Planning Commission June 20, 2024

Location: 6497 Tillery Drive

Subdivision Name: Cooley Tract Subdivision

• Subdivision approval to create one (1) legal lot of record from two (2) metes-and-bounds parcels.

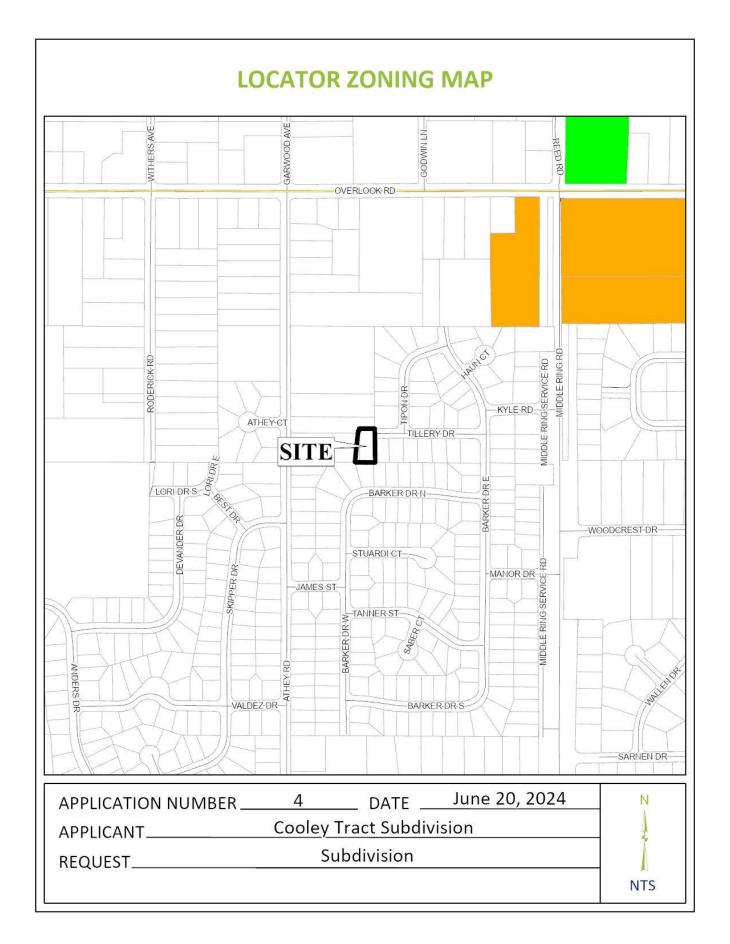
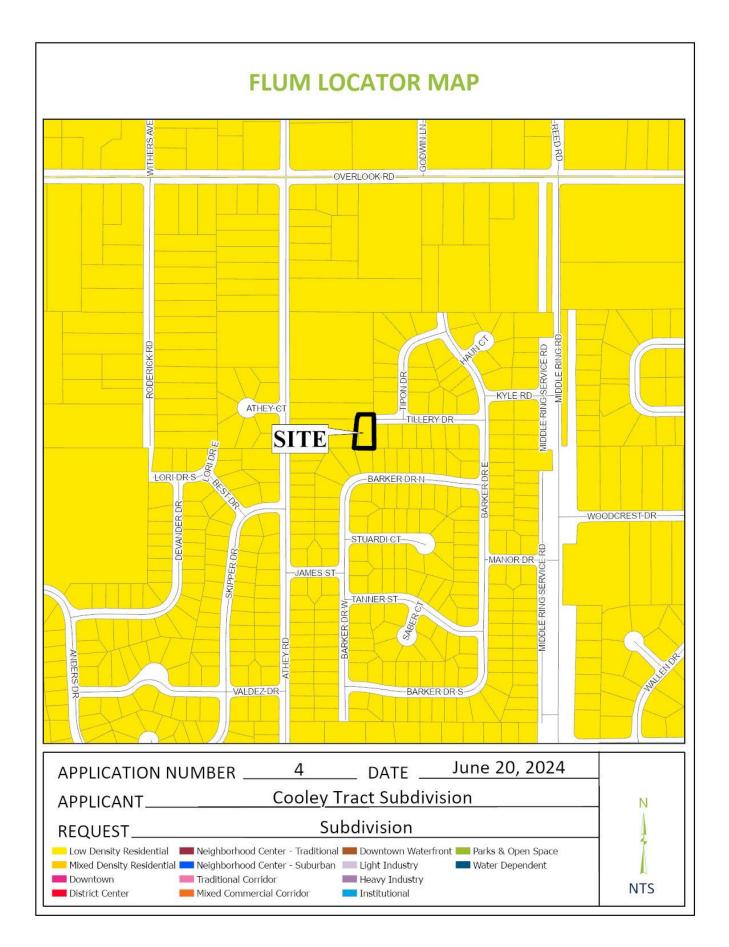
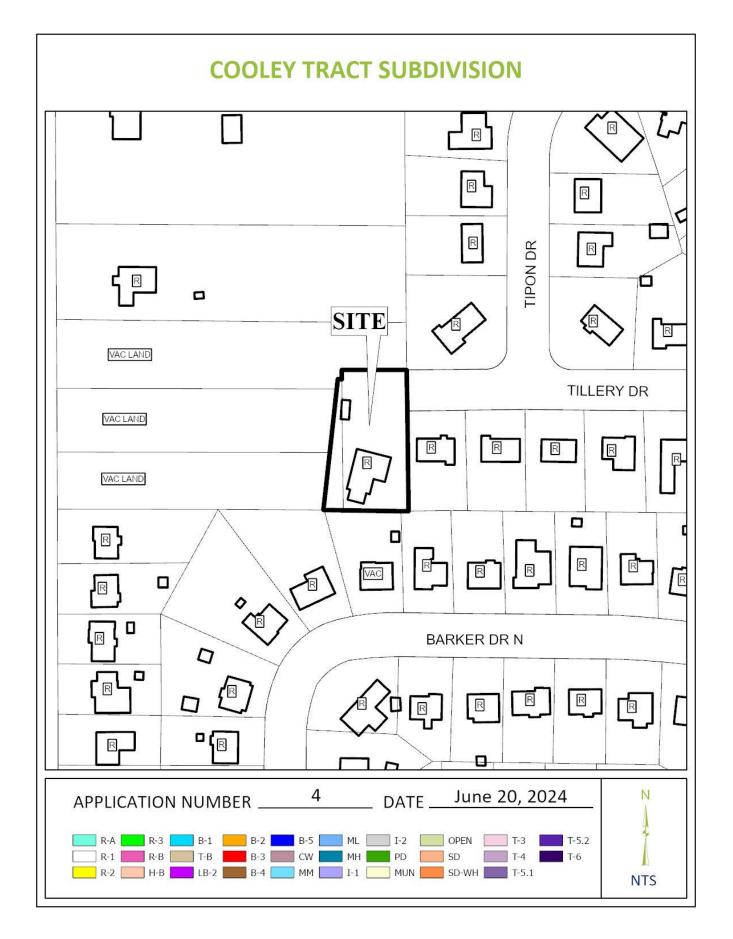
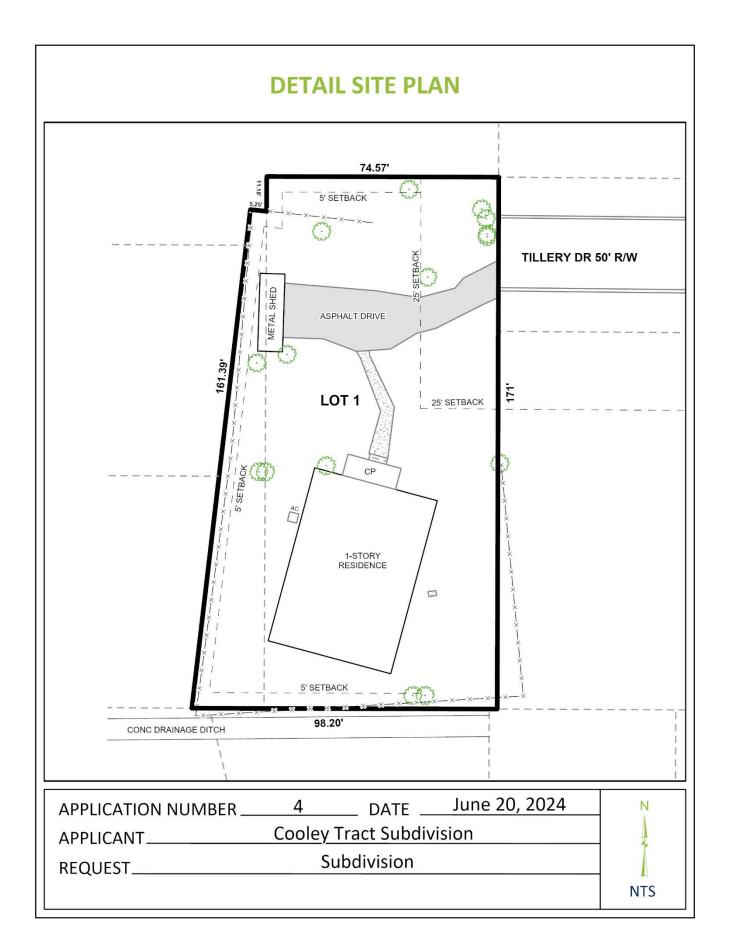
The preliminary plat does not provide the specifications for Final Plat approval regarding the general form, information to be shown, or attendant items required by Section 5 of the Subdivision Regulations. Such requirements include the items, notes, and certifications that should be placed on a subdivision plat. As such, the Final Plat should provide all the information required by Section 5 of the Subdivision Regulations, along with any additional information required by the Engineering Department.

The proposed lot has frontage at the West terminus of Tillery Drive, a minor street with curb and gutter and a compliant 50-foot right-of-way. The right-of-way width of Tillery Drive should be retained on the Final Plat, if approved. The preliminary plat indicates a 25-foot minimum building setback line blocked-out from the terminus of Tillery Drive, and this should be retained on the Final Plat, if approved. The five-foot (5') building line should be removed from the side and rear property lines on the Final Plat.

Tillery Drive is a dead-end street. While dead-end streets would typically require some type of provision for a turnaround, this is an existing condition and would not create/provide for an additional home on the dead-end street; therefore, a waiver of Section 6.B.3. of the Subdivision Regulations may be appropriate.

As per boundary dimensions provided on the preliminary plat, the lot, as proposed, exceeds the minimum size requirements for lots served by public water and sanitary sewer in an R-1, Single-Family Residential Suburban District. The lot size, however, is not labeled in either square feet or acres, as required by Section 5.A.2(e)(4) of the Subdivision Regulations. If approved, the lot size in both square feet and acres should be labeled on the Final Plat; or a table should be furnished on the Final Plat providing the same information.

- 1. Provision of a subdivision plat in compliance with Section 5 of the Subdivision Regulations;
- 2. Retention of the right-of-way width of Tillery Drive on the Final Plat;

- 3. Retention of the 25-foot minimum building setback line blocked-out from the terminus of Tillery Drive on the Final Plat;
- 4. Revision of the plat to remove the five-foot (5') building setback line along the side and rear property lines;

- 5. Revision of the plat to label the lot with its size in both square feet and acres, or the furnishing of a table on the Final Plat providing the same information;
